Westbrook Elementary School, Preliminary Forest Conservation Plan, MR2012006

- **Preliminary Forest Conservation Plan and Variance**
- 5112 Allan Terrace, Bethesda MD
- Approximately 12.13 acres
- Zoned R-60
- Located within the Palisades sub area of the 1990 Bethesda -Chevy Chase Master Plan area
- Application submitted on 9/29/11 by
- Montgomery County Public Schools (MCPS)

- Area 1 staff has reviewed the Preliminary Forest Conservation plan for **MR2012006** and **recommends APPROVAL with conditions** of the Preliminary Forest Conservation Plan and associated variance request.

Image from submitted PFCP. The triangular shapes in the center of image are examples of existing forest areas (within the floodplain/SVB) that are defined as cleared by the plan.

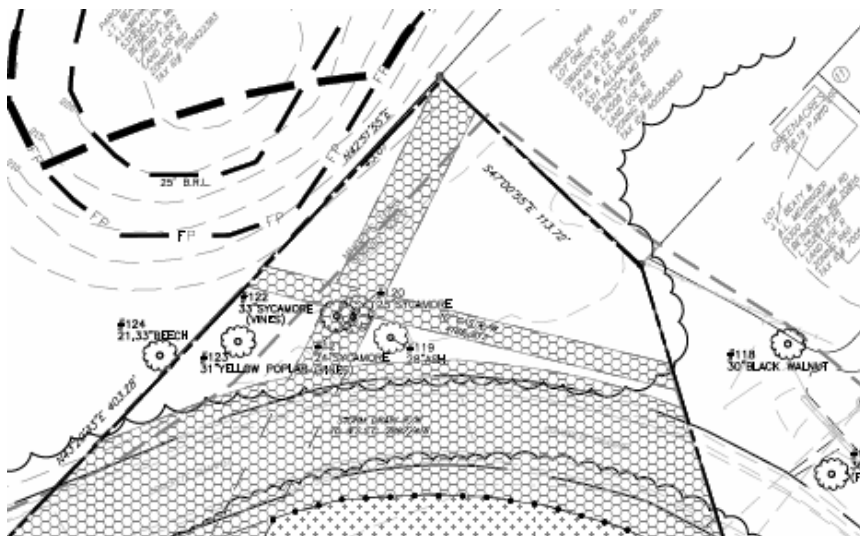
The submitted plan shows several areas of high priority forest within the 100 year floodplain/SVB as being cleared (see image above for examples). The forest areas in question are not within the LOD associated with the school project, however the same forest areas are not proposed to be included within the protective easement. By definition, the forest areas outside of the proposed conservation easements are considered to be cleared. The clearing figures are reflected in the submitted forest conservation worksheet which identifies 1.26 acres of high priority forest clearing. If the plan were approved as submitted, the forest areas covered by the plan which are outside of the easement footprint could be cleared in the future with no further input from M-NCPPPC. Some of the forest areas shown as cleared also contain trees which are $\geq 30''$ and would therefore be subject to variance (since they part of the forest proposed as cleared). M-NCPPPC does not have any indication that MCPS intends on actually performing the clearing outside of the LOD. Therefore the condition to show additional areas of conservation easement is necessary to consider the application as complete, since the variance request does not mention the clearing beyond the LOD and the variance request must be consistent with the plan.

Providing the additional Conservation Easement areas (per the recommended condition) will make the plan consistent with the requested variance and meet environmental guidelines and master plan recommendations. The recommended change includes deducting only the areas of concrete stream channel from the net tract area. The Forest Conservation Plan and associated worksheet shall be adjusted accordingly.

L-2.3

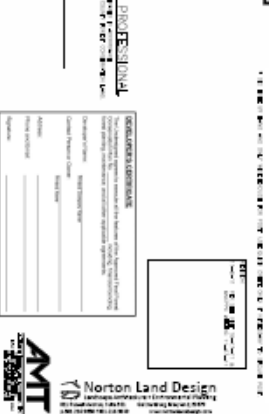
7. Revise the Forest Conservation Worksheet to deduct only the concrete stream channel from the net tract area.
8. Extend the LOD for the SWM retrofits (at the northwest side of the school) shown on sheets L-2.1 to connect with the remainder of the work proposed along the west side of the school.
